# UNITED STATES PATENT AND TRADEMARK OFFICE

APPLICATION NO.	FILING DATE	FIRST NAMED INVENTOR	ATTORNEY DOCKET NO.	CONFIRMATION NO.
10/560,661	10/31/2006	Daniel Irimia	00786-0683US1 / MGH 2347	2265
26161 7590 06/24/2010 FISH & RICHARDSON PC P.O. BOX 1022 MINNEAPOLIS, MN 55440-1022			EXAMINER BEISNER, WILLIAM H	
			ART UNIT 1797	PAPER NUMBER
			NOTIFICATION DATE 06/24/2010	DELIVERY MODE ELECTRONIC

<b>Office Action Summary</b>	<b>Application No.</b> 10/560,661	<b>Applicant(s)</b> IRIMIA ET AL.	
	<b>Examiner</b> WILLIAM H. BEISNER	<b>Art Unit</b> 1797

Figure 9.

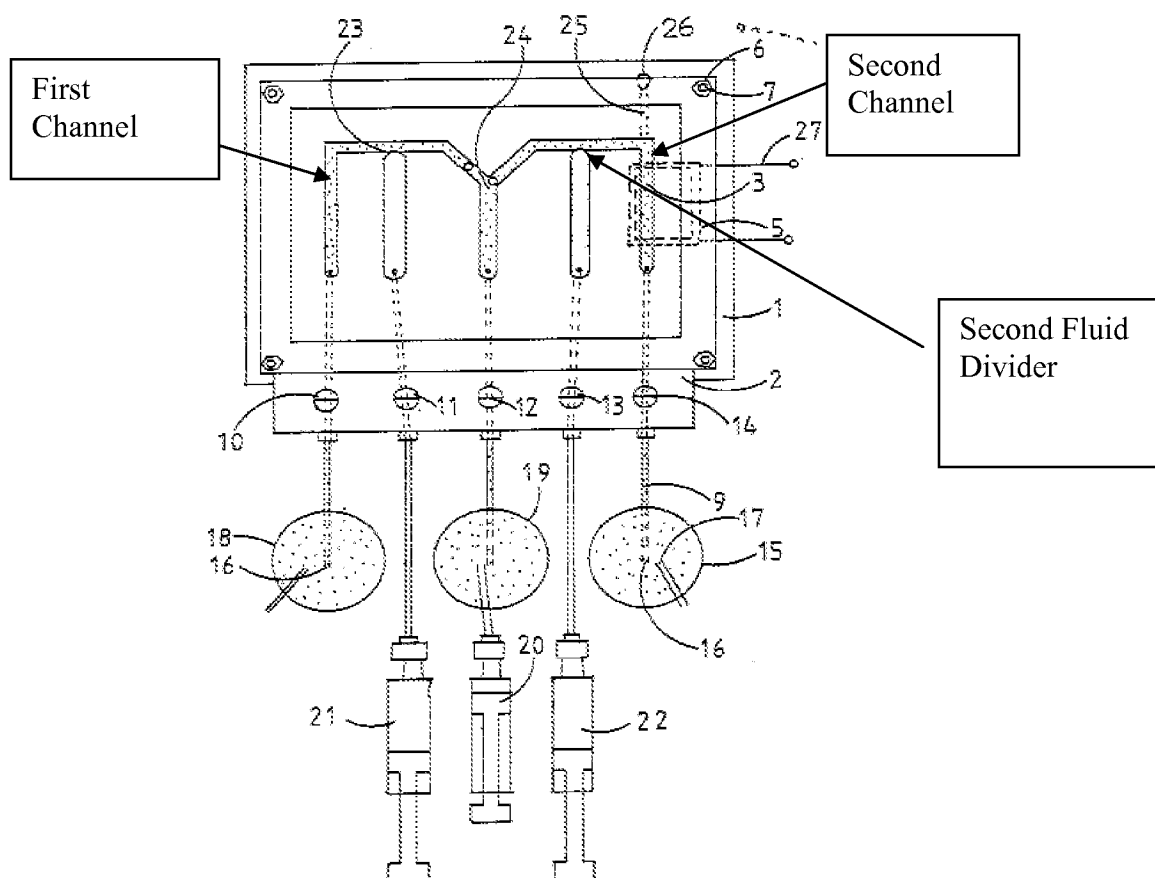
With respect to claim 1, the reference of Stewart discloses a device (See Fig. 9 and image reproduced below) for contacting two volumes of fluid that includes a first channel having a fluid inlet (10) and a first fluid divider (23) for dividing the fluid in the first channel into discrete segments; a second channel having a second inlet (14) and a second fluid divider for dividing the fluid in the second channel into discrete segments; and a third channel (24) connecting the first and second channels.

With respect to claim 2, the fluid dividers are capable of being in communication with sources of immiscible fluid.

With respect to claim 3, the source of immiscible fluid can be enclosed chamber (21,22) or the chambers on the substrate device.

With respect to claims 4 and 5, the first and second channels includes constructions (23).
